RESPONSE TO REQUESTS FOR INFORMATION (RFI)

**Proposed Waste Management facility (SSD-62855708)
2-4 Hale Street, Botany**

Reference: 23.464r07v05
Date: September 2025

Figure 1: 26m B-Double Vehicle Entering the Site

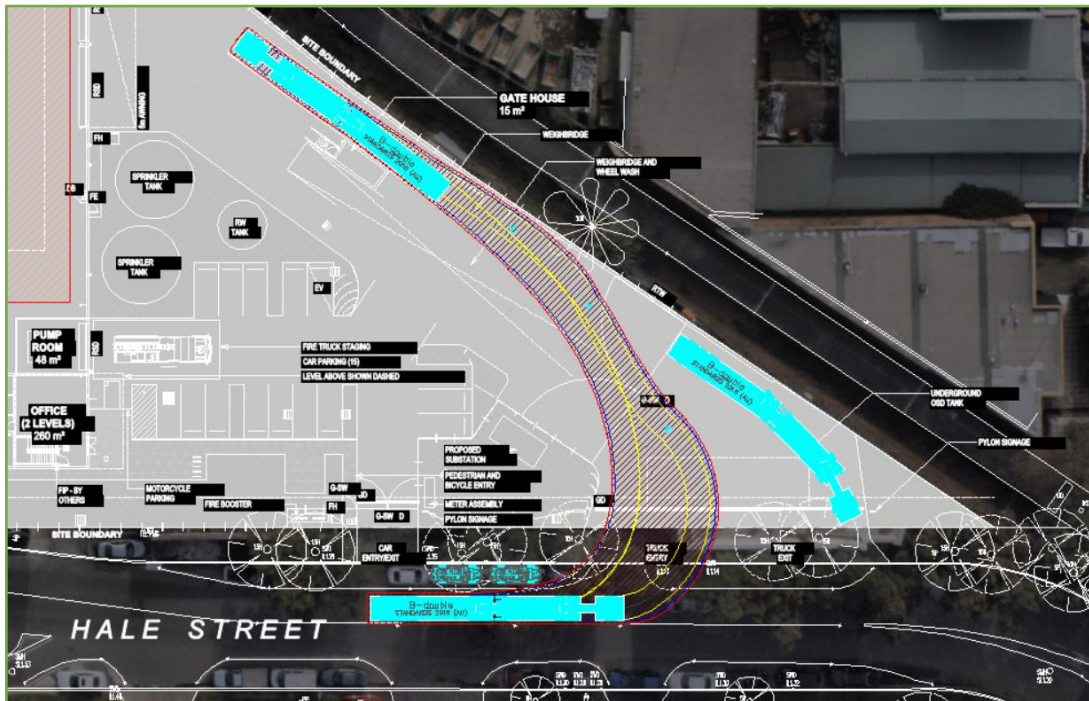
The swept path analysis shows the movement of a B-double exiting the site on a separate drawing to the swept path of a B-double accessing the site. It is not possible to determine if there will be any conflicts if these two movements occur simultaneously. Please provide a plan that shows a B- double entering and exiting the site simultaneously demonstrating that this movement can occur safely and without any conflict to either vehicle or on-street parking, and without crossing the centreline of Hale Street.

The swept path analysis provided in **Appendix C** of the amended TIA has been separated in response to earlier Council comments to prevent further misinterpretation of the swept path diagrams raised in the first round of comments.

Having considered the above, **Figure 1** below clearly demonstrates a 26m B-double vehicle will be able to satisfactorily enter the site whilst another 26m B-double vehicle is waiting to exit the site, under conservative operational assumptions.

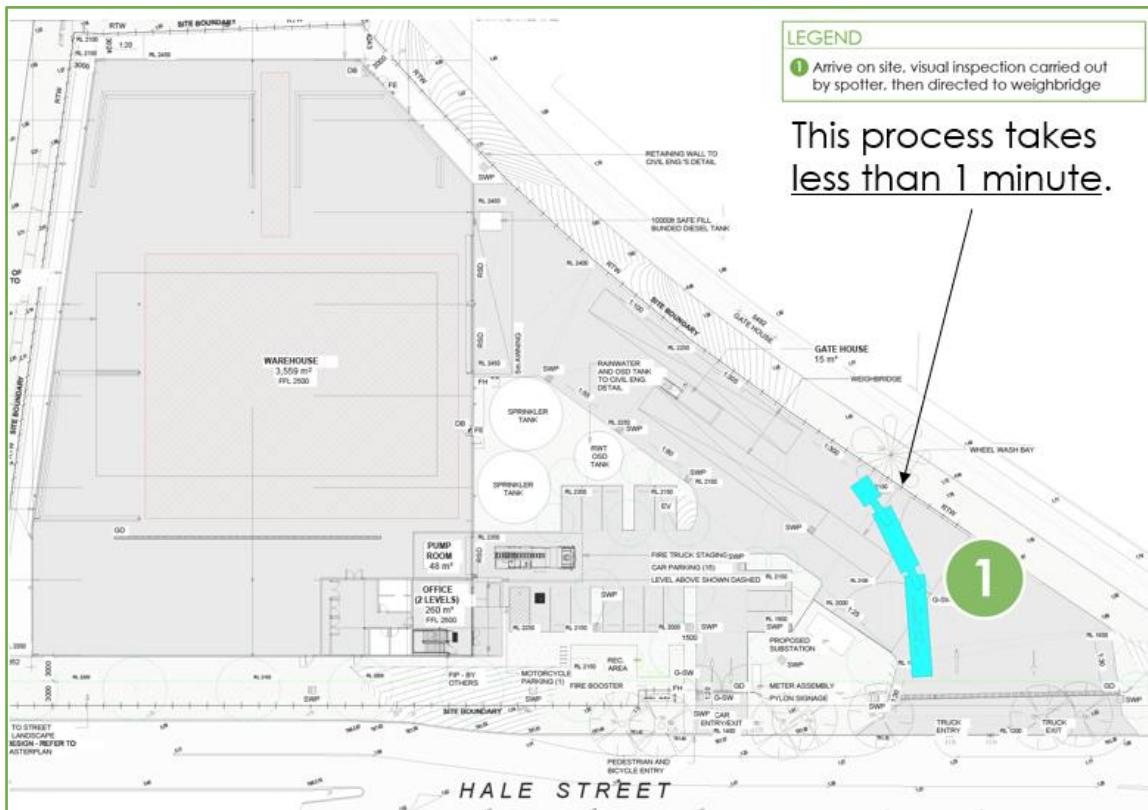
<p>e) A plan showing seven (7) 25.0m – 26.0m B-Doubles as part of Appendix E, as identified in Section 9.8, Drawing 23.464 TX.02 is titled "Site Circulation and Queueing", but does not show where vehicles can queue. Additionally, a bottleneck effect is likely to occur since a truck might park another truck in while waiting.</p>	Appendix E
<p>f) Council requests for the Traffic Engineer to confirm that the SIDRA modelling has been undertaken as a network model including all modelled intersections, as opposed to separated intersection models, to confirm that queueing is not expected to occur over key intersection/ site accesses.</p>	Section 9.5.4
<p>g) The basis for the "truck on site dwell times" listed on Table 17 (page 16 of the TIA) shall be confirmed. It is not appropriate to provide this data without providing evidence such as a case study of footage of a similar site. The truck dwell times need to be firmly substantiated by supporting evidence as these truck dwell times in the TIA appear to be very short.</p>	Section 9.8

The queuing assessment that has been undertaken is not an M/M/7 queue, it is a staged M/M/1 queue since only one truck can be serviced at any one time at each stage within the queue. Arrivals are not uniformly distributed as inferred by Council, rather they are random arrivals based on a Poisson distribution model and truck arrivals are assessed in terms of probabilities rather than a uniform arrival rate, which is how the queuing assessment has been undertaken in accordance with Austroads Guidelines. Expressing truck arrivals as uniform arrivals per unit of time, even in the misguided attempt to prove a theoretical point, has no relevance in terms of how the queuing assessment is undertaken. In short, the queuing assessment undertaken by TRAFFIX clearly demonstrates the 98th percentile queue is comfortably accommodated onsite.

Drawing Title
 Site Plan (Rev. L)
 Design Vehicle: 26m B-Double
 Movement: Site Circulation including Queuing

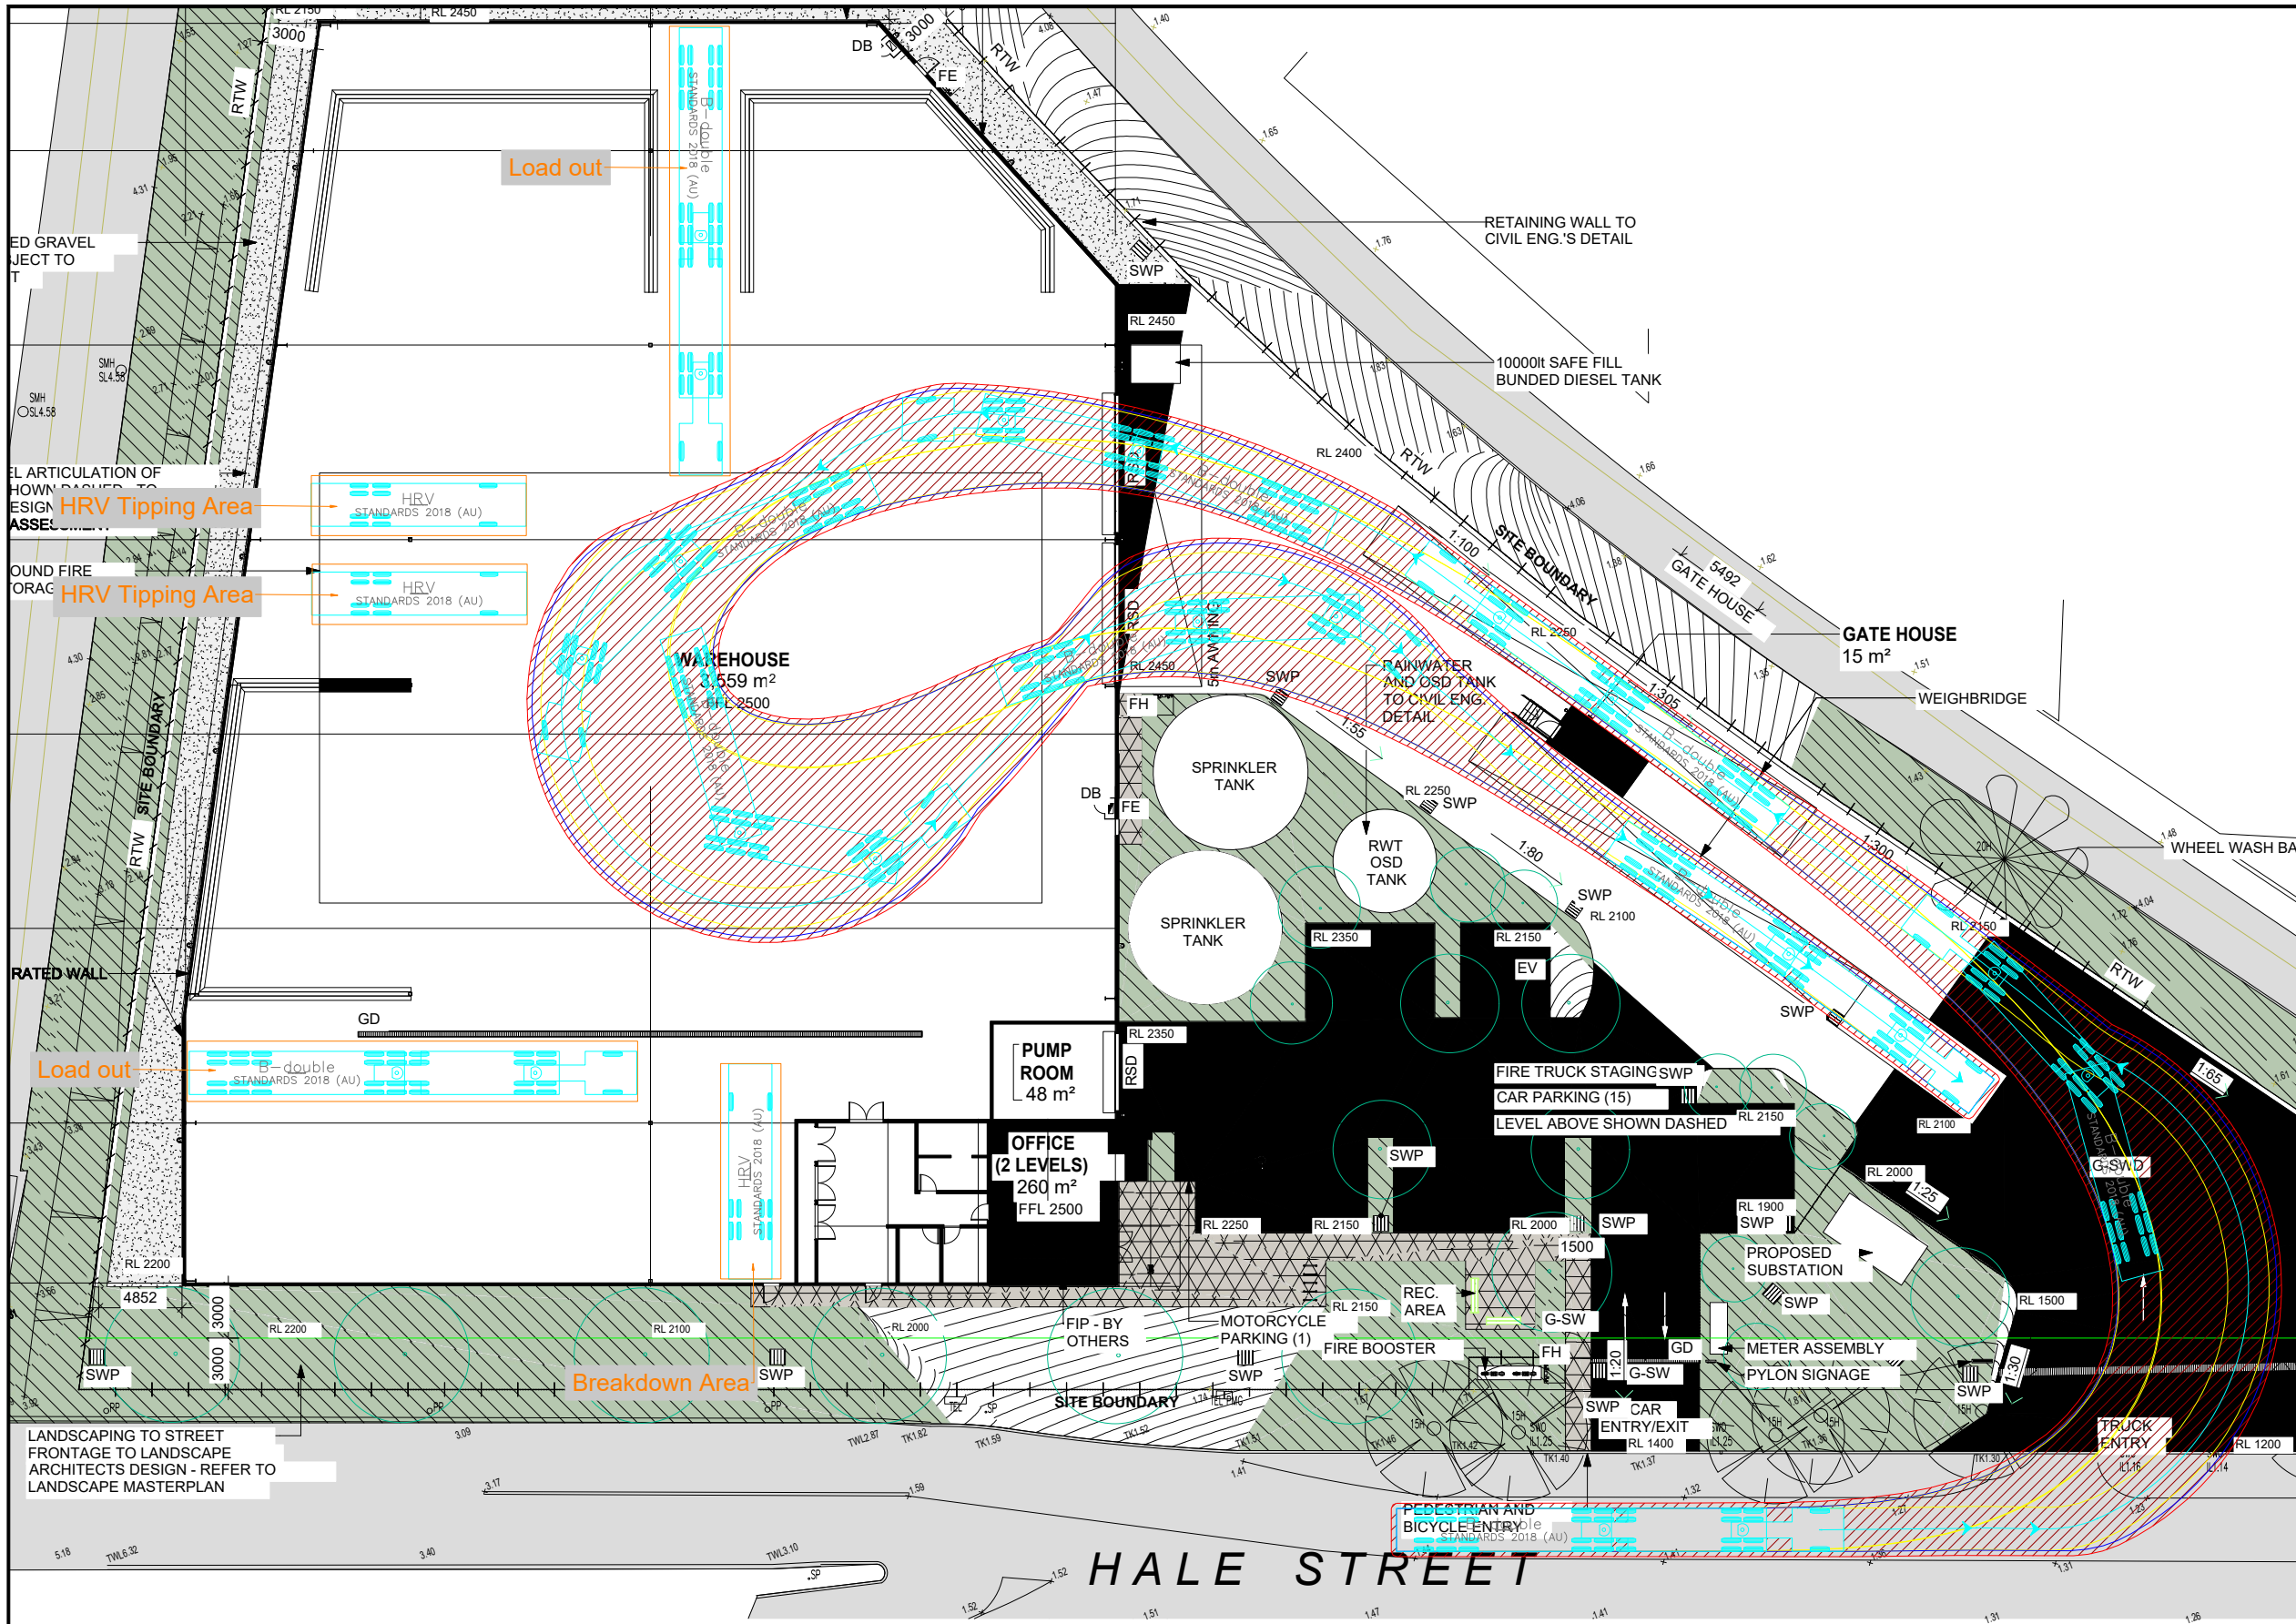
- c) **A plan showing seven (7) 25.0m – 26.0m B-Doubles as part of Appendix E, as identified in Section 9.8, Drawing 23.464 TX.02 is titled “Site Circulation and Queueing”, but does not show where vehicles can queue. Additionally, a bottleneck effect is likely to occur since a truck might park another truck in while waiting.**

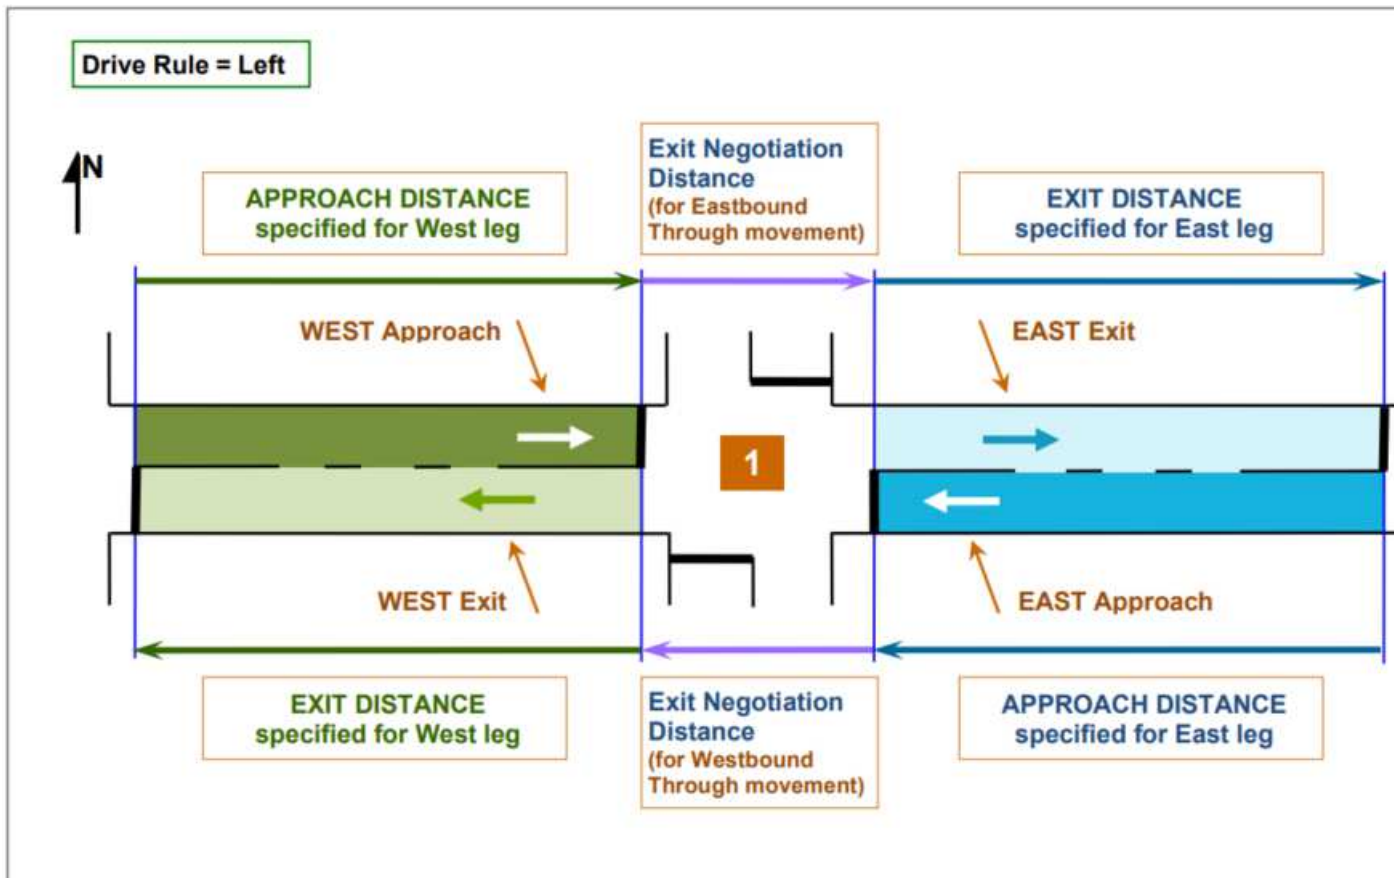
Finished reviewing the SIDRA model and comments are as follows:

- *Traffic generation analysis has been checked and is acceptable, noting that there's an updated guide for traffic generation (TfNSW GTIA 2025) but since the original assessment was undertaken in late 2023 (according to document control table at the front of the TIA), it'd be unreasonable for them to have updated. In addition, since the generation rate was used to estimate existing volume, rather than proposed volume (which was done with a first-principles assessment), it would increase the net reduction.*

- *Old rates (GTGD 2022) are 1 trip per 100m² GFA*
 - *New rates (GTIA 2024) are:*
 - *1.69 trips per 100m² GFA in the AM and*
 - *1.20 trips per 100m² in the PM*
